CITY OF MERIDIAN FINDINGS OF FACT, CONCLUSIONS OF LAW AND DECISION & ORDER

In the Matter of the Request for a Modification to the Development Agreement to Update the Conceptual Development Plan and Building Elevations; and Combined Preliminary and Final Plat Consisting of Three (3) Building Lots on 2.20 Acres of Land in the C-C (Community Business) Zoning District for Bountiful Commons East, by KM Engineering, LLP.

Case No(s). H-2022-0015

HEARING DATE:	July 19, 2022 Continued from: June 21, 2022
TO:	Mayor & City Council
FROM:	Sonya Allen, Associate Planner 208-884-5533
SUBJECT:	H-2022-0015 Bountiful Commons – MDA, PFP

B. Proposed Conceptual Development Plan (NOT APPROVED) & Elevations to be Included in Amended Development Agreement

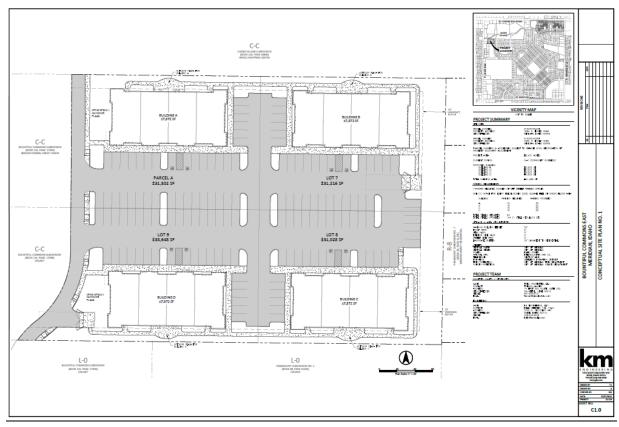
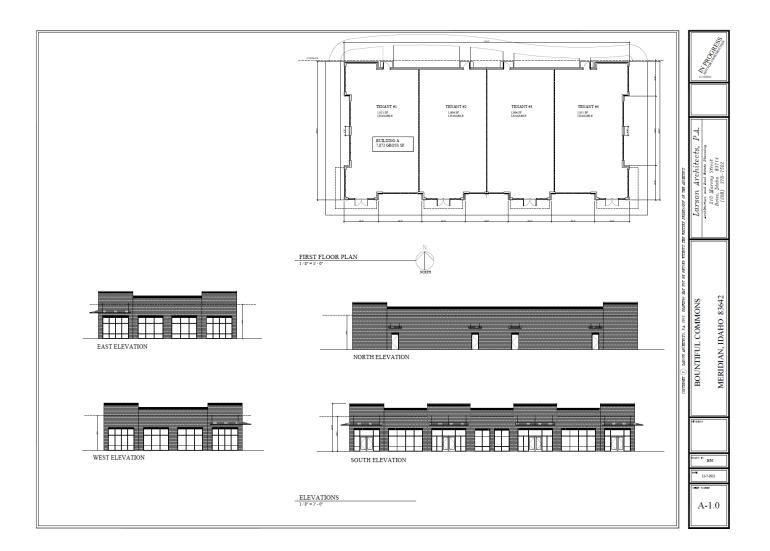
A north/south backage road exists along the west boundary of this site that provides an access from the collector street (W. Cayuse Creek Dr.) to the north to Linder Rd. at the south boundary of Bountiful Commons Subdivision. Staff is concerned the ten (10) parking spaces depicted on the site plan along the west boundary of the site will create a safety hazard by vehicles backing out into traffic; therefore, Staff recommends these spaces are removed from the plan.

An existing provision of the DA (#5.1b) requires a minimum of 5% of the development area to be developed with supportive and proportional public and/or quasi-public spaces and places. Based on 2.93 acres, a minimum area of 0.15-acre (or 6,382 square feet) would be required. In mixed use designated areas where multiple commercial and/or office buildings are proposed, the Comprehensive Plan also desires buildings to be arranged to create some form of common, usable area, such as a plaza or green space. To create more of a shared common usable area as desired, Staff recommends instead of individual outdoor plaza areas for each building, the parking areas in between Buildings A & B and C & D are removed and a plaza/green space is provided in these areas with seating, landscaping and shade structures.

Staff is generally supportive of the proposed modification to the DA with the recommended changes to the conceptual development plan noted above. Staff recommends the Applicant revise the plans to incorporate these changes and submit a copy of the revised plan to the Planning Division at least 10 days prior to the City Council hearing.

Staff recommends the Applicant revise the conceptual development plan depicted in Section VII.B to incorporate the changes noted in Section V.A and submit a copy of the revised plan to the Planning Division at least 10 days prior to the City Council hearing. A revised plan was submitted after the Commission hearing that incorporated some but not all of Staff's recommended changes (see Sections VI.B.5 and VII.B for more info). The Council did not require removal of the parking between the buildings in order to provide central plazas in those areas as recommended by Staff.

- The existing Development Agreement (DA) (Inst. #2018-052340, H-2017-0095) for Linder Mixed Use shall be amended as proposed by the Applicant with the changes to the conceptual development plan-recommended by Staff required by City Council. The amended DA shall be signed by the property owner and returned to the Planning Division within six (6) months of the City Council granting approval of the amendment. The amended DA shall include the following provisions as required by City Council:

Updated (dated: 7/7/22):

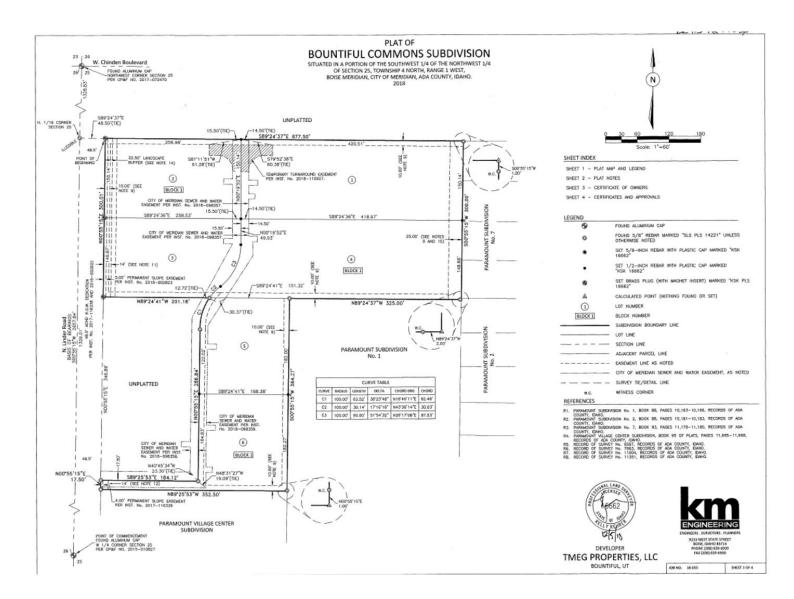
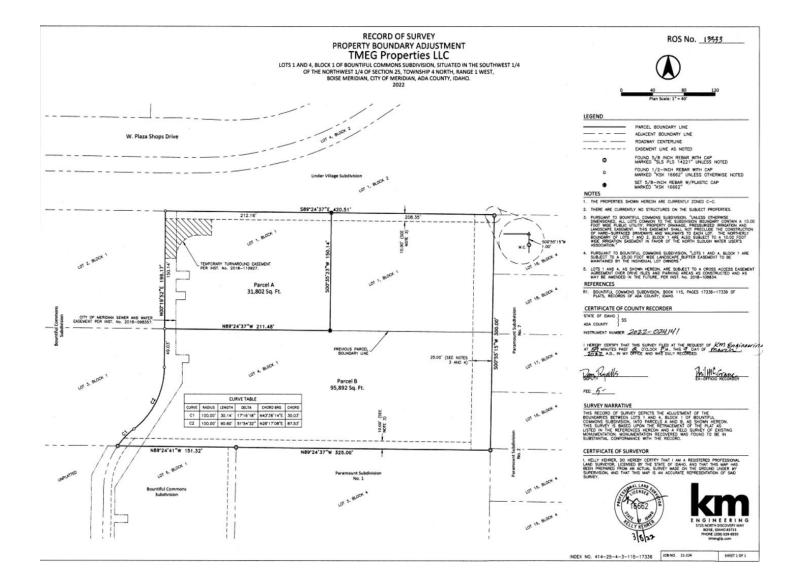
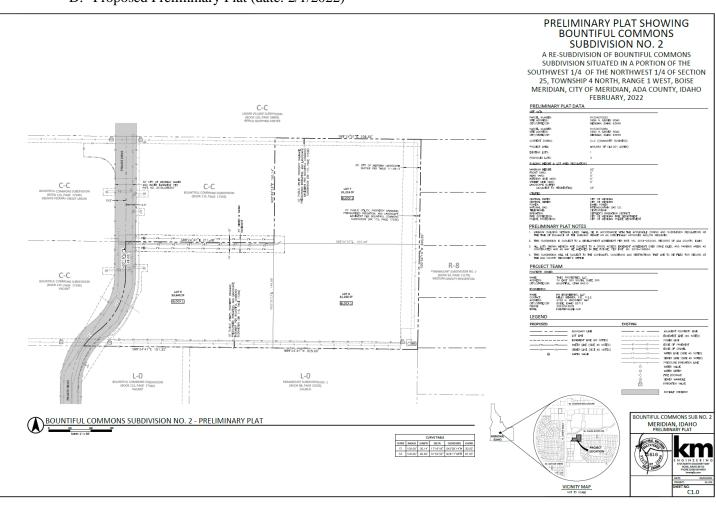
- <u>4.</u> <u>Commission change(s) to Staff recommendation:</u>
 - <u>a.</u> <u>None</u>
- 5. Outstanding issue(s) for City Council:
 - a. The applicant submitted a revised site/landscape plan after the Commission hearing that depicts the removal of 10 parking spaces along the west boundary of the site as recommended by Staff and the Commission. Other changes as recommended by Staff were not included in accord with the Commission's discussion (i.e. removal of individual outdoor plaza areas for each building and the parking areas in between Buildings A & B and C & D in favor of provision of plaza/green spaces in these areas with seating, landscaping and shade structures).

- a. <u>City Council required the removal of the provision requiring central plazas between the buildings;</u>

E. Proposed Final Plat (dated: 2/4/2022)

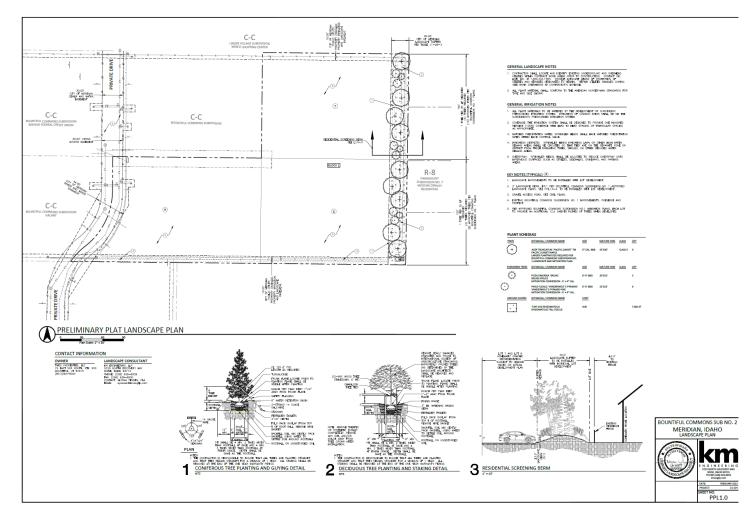
- 2. The final plat shall include the following revisions:
 - a. Include the recorded instrument of the City of Meridian sewer and water easement graphically depicted on Sheet 1.
